Ride Report: **LLDC Park Ride** 18 July 2018

Author: Jonathan Rothwell

Where We Went

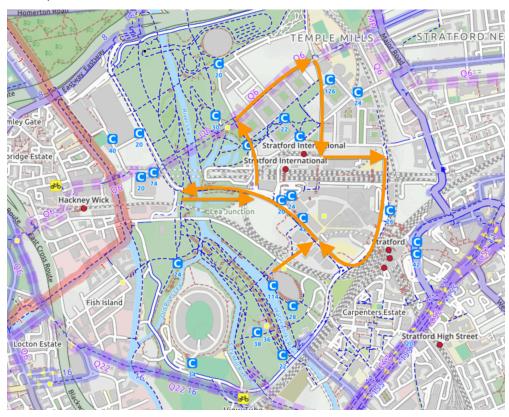
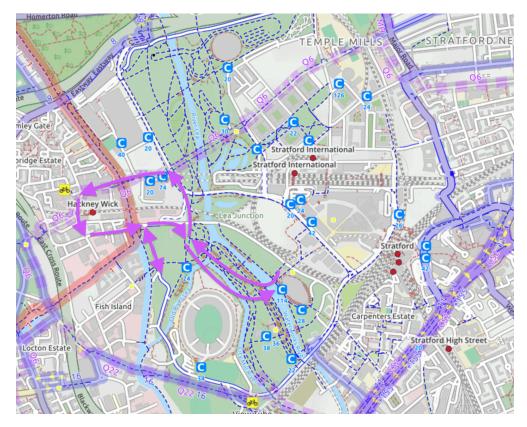
- 1. Westfield Avenue
- 2. Waterden Road j/w Clarinoco Lane and new North/South Highway
- 3. Westfield Avenue j/w Olympic Park Avenue bridge
- 4. Olympic Park Avenue j/w Honour Lea Avenue (future Quietway 6)
- 5. Honour Lea Avenue j/w Celebration Avenue
- 6. International Way
- 7. Montfichet Road
- 8. Return via Westfield Ave

- 1. 2012 Walk
- 2. Waterden Road/Copper Street (future Quietway 6)
- 3. Wallis Road
- 4. White Post Lane
- 5. Carpenters Road
- 6. Loop Road
- 7. return via Carpenters Road/2012 Walk
